APPENDIX G

FORMER BURN PIT AREA EXCAVATION LIMITS
REEVALUATION

From: Cem Gokcora
Sent: Friday, August 28, 2020 7:45 AM
To: MCDONNELL Erin
Cc: Erik Bakkom (ebakkom@maulfoster.com); 'PARRETT Kevin'
Subject: AMCCO Burn Pile Excavation Boundary Reevaluation
Attachments: Dike Excavation Analysis.pdf

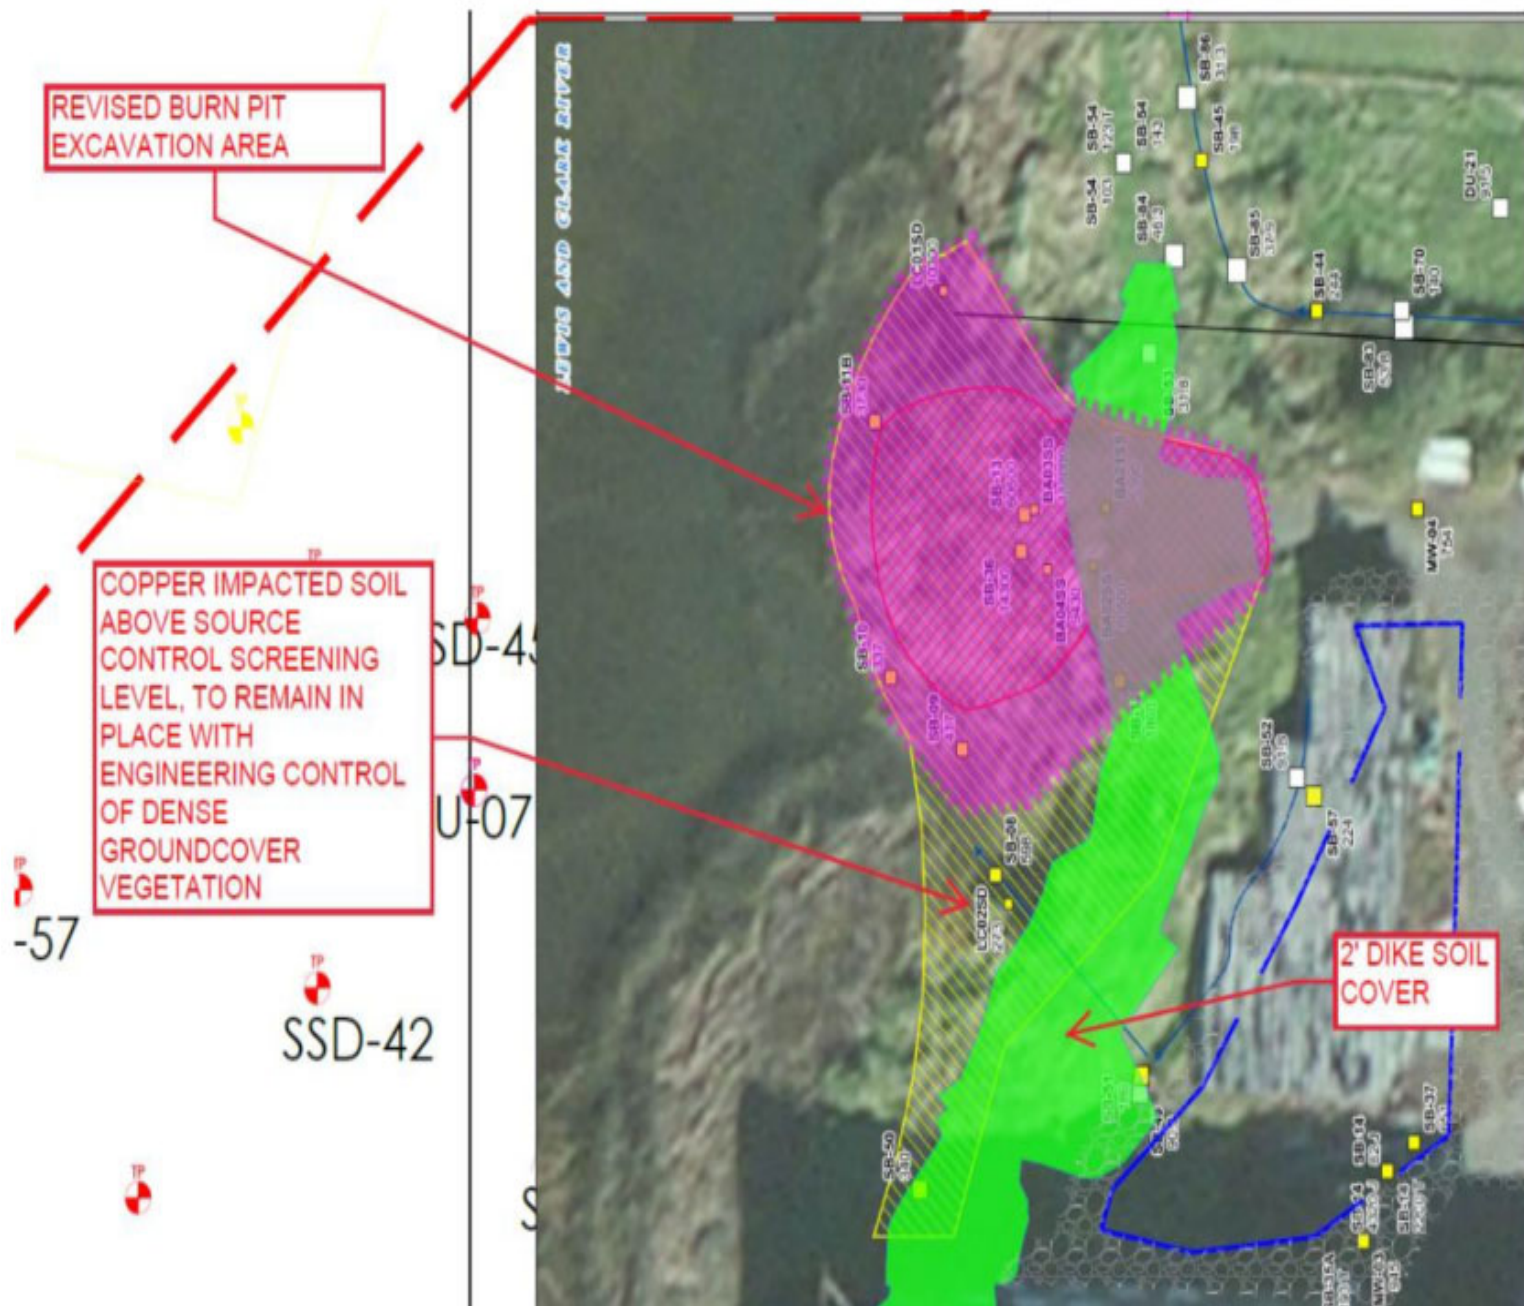
5. Analysis of the physical erosion risk was not performed at the time, so the basis for excavation assumes that soil exceeding sediment cleanup levels on the levee face will erode en masse and be deposited directly in the sediment bed without dispersion or mixing, a highly unlikely situation.
6. The physical erosion risk of all soil on the face of the existing dike is very minimal due to the dense vegetative cover that is required by the Corp of Engineers.
7. The vegetative cover is maintained rigorously by the local Diking District as part of their dike maintenance responsibilities to the residents of the district and as mandated by their operational agreements with the Corps.

8. The dike restoration design is required to provide 2-3 feet of additional fill in order to restore the originally authorized height (area shown in green below).
9. Dike fill on the crest road provides an engineering control that will cap any low-level soil contamination that remains in place.
10. To be considered, the removal of surface soil from the dike and revegetation will result in a period of elevated risk to residents while the grass cover is re-establishing significant root structures. Limiting the disturbance of the protective dike vegetation systems will reduce the short-term risk of dike failure.

FIGURE 7a

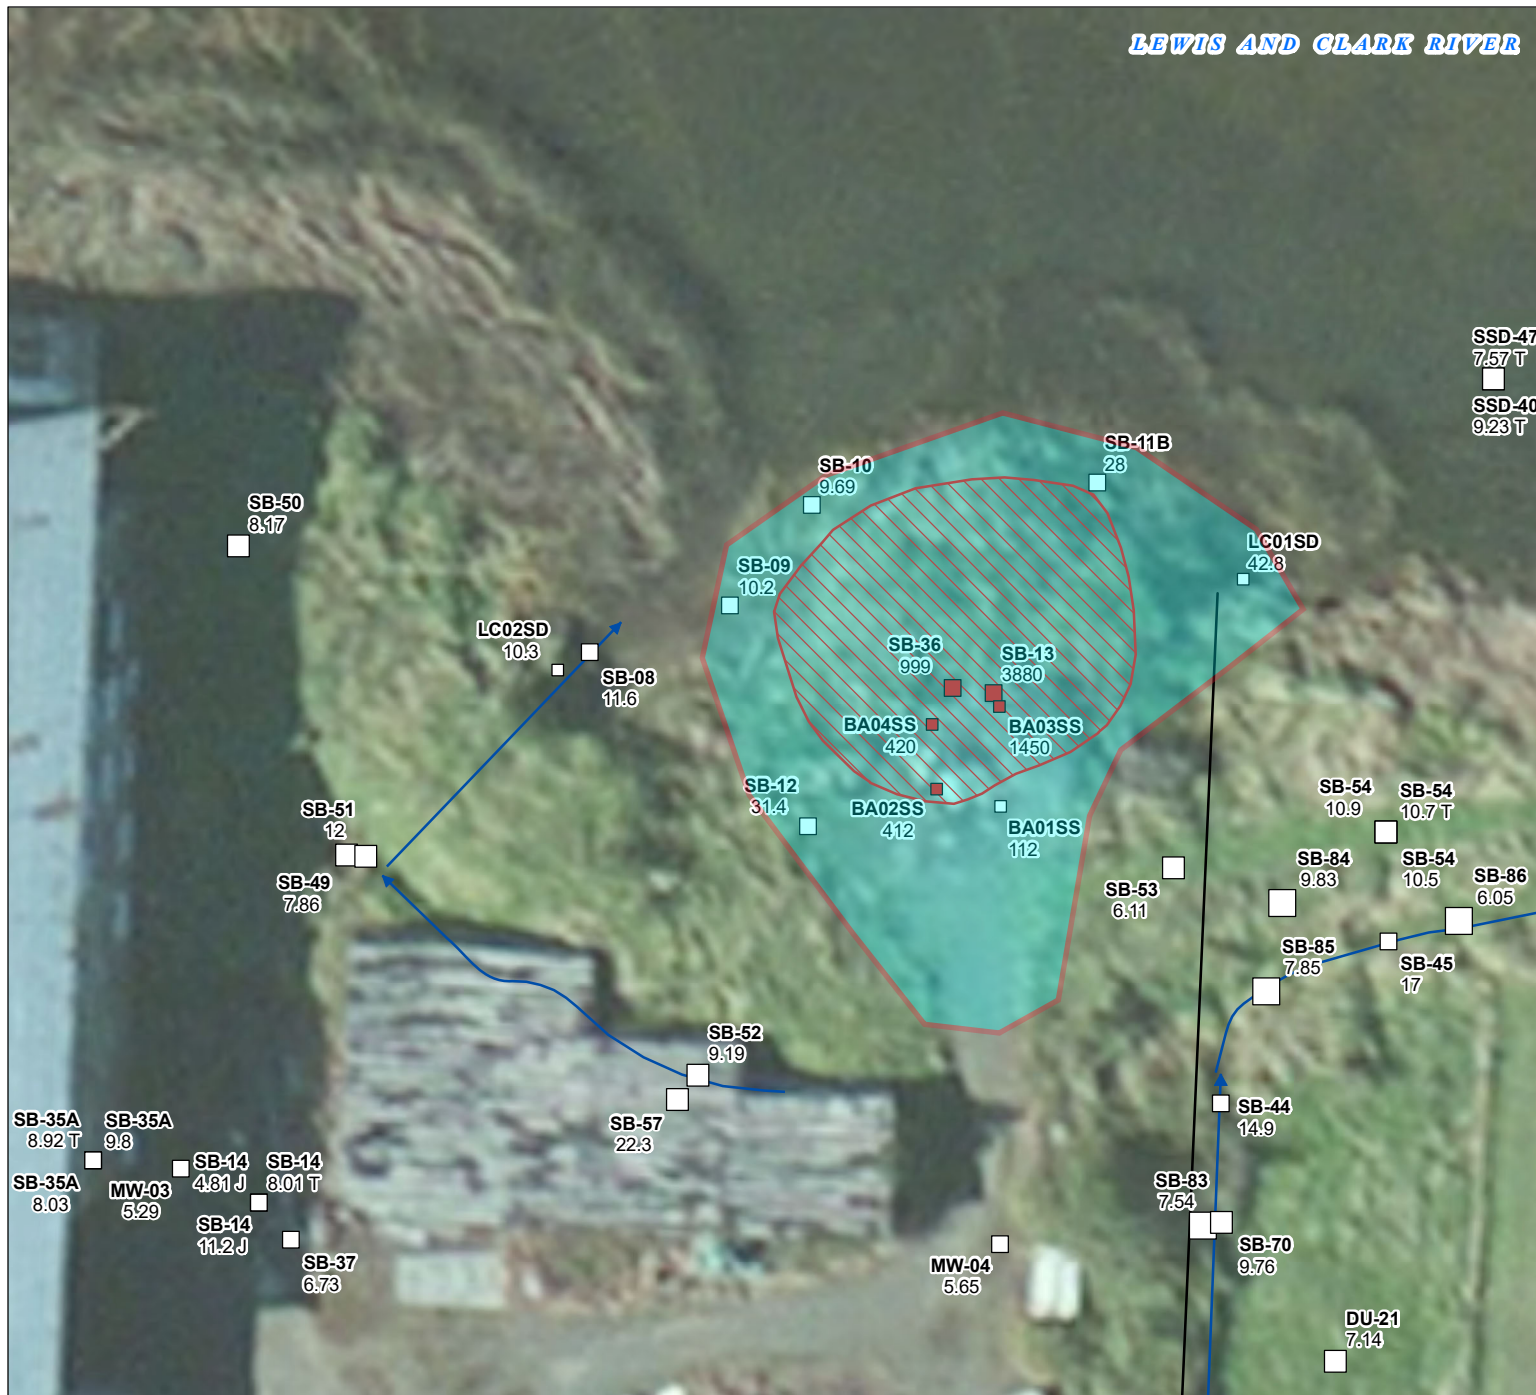
1. On Figure 7a, GSI identified the extent of a 2-foot depth Burn Pit excavation boundary which addresses source control risk based on copper shown as a yellow boundary.
2. The red boundary identifies a much smaller area where arsenic exceeds source control or hotspot criteria (see Figure 5a for arsenic details in shallow soil).
3. RI sampling results for these upland samples were screened against the sediment clean up levels, as described in bullet two of the drawing notes.
4. The pathway of concern is the erosion of soil directly to the Lewis & Clark River sediment.

11. The source control risk is from copper only, there are no other contaminants at levels of concern that are identified in the drawing set prepared by GSI.
12. The hotspot concentration that is established for copper is 120,000 mg/kg, and the source control concentration that is used in the figure analysis is 149 mg/kg.

13. AMCCO proposes to leave in place in the southern portion of the shallow excavation, where copper concentrations are below 1,000 ppm, more than two orders of magnitude lower than the upland hotspot concentration.

17. An area of 5,400 SF of copper impacted soil is proposed to be left in place, approximately 500 CY.
18. After accounting for cover by the dike crest road, approximately 3,000 SF of copper impacted will be addressed by an engineering control of dense vegetative ground cover.
